**From:** Collette, Anja  
**To:** Scott Bralov  
**Cc:** "Emily Ellis"; Tim Pease; Szewczyk, David; Kriego, Anne M.  
**Subject:** Maine Woods - additional clarifications requested  
**Date:** Wednesday, November 15, 2023 1:53:43 PM  
**Attachments:** image001.png  
 image002.png  
 image003.png  
 image004.png  
 image005.png  
 image007.png  
 image008.png

Utility symbols

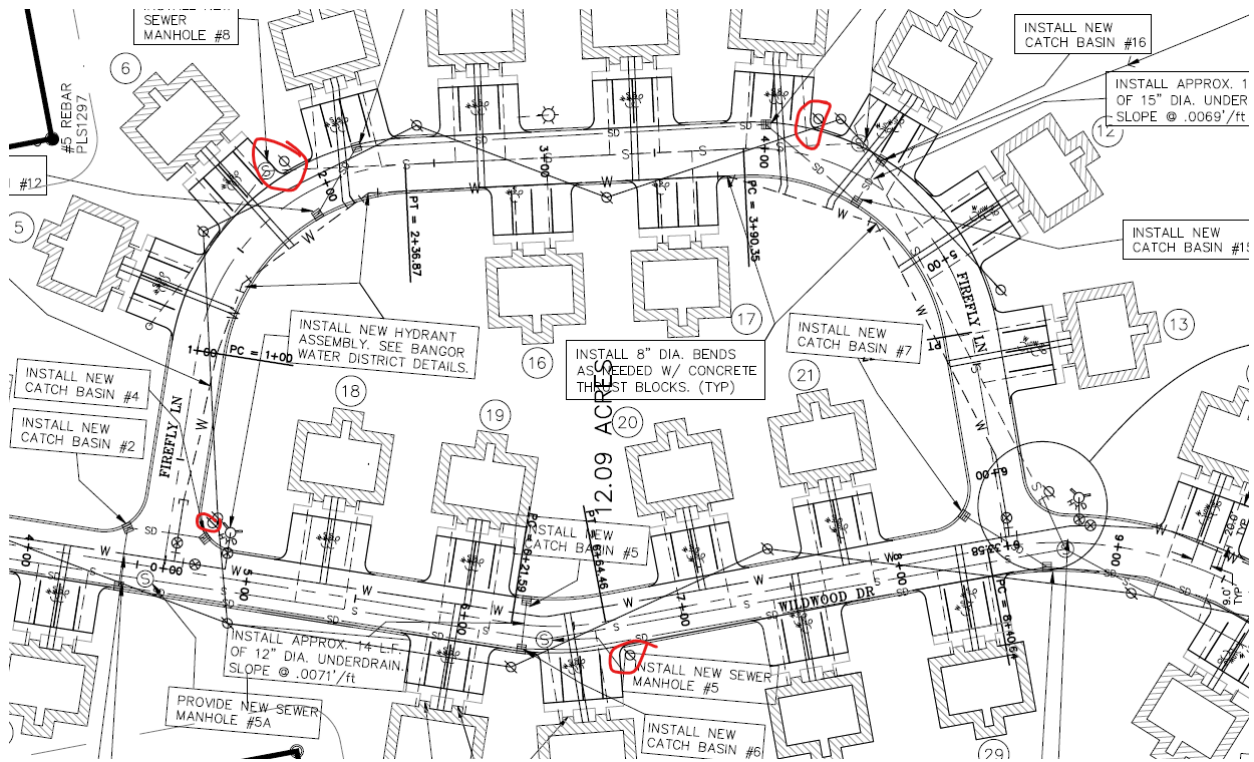
- It looks like there are some areas where the old utility pole locations were left on the plans (see below). For clarity's sake, it would be good to remove these from the plans, unless they're supposed to be there.

Buffering

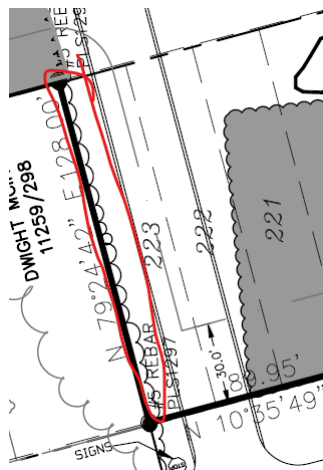
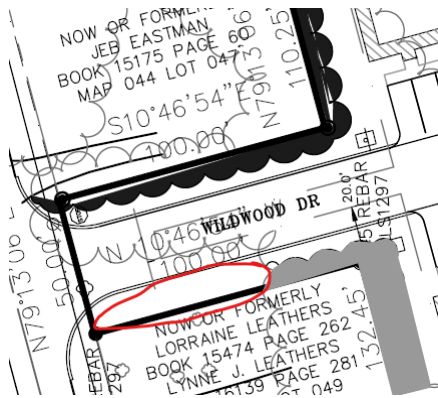
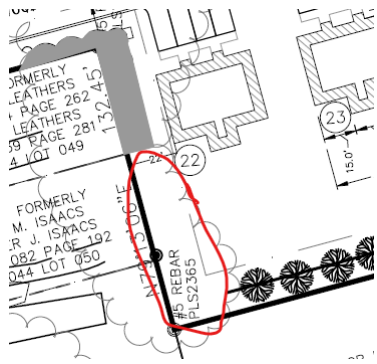
- There are still some remaining gaps in the lot line buffers, shown in the pictures at the bottom. In the first and second buffer pictures, buffer A Subtype 2 may need to be used given the confined area (Subtype 2 has a width of 6').
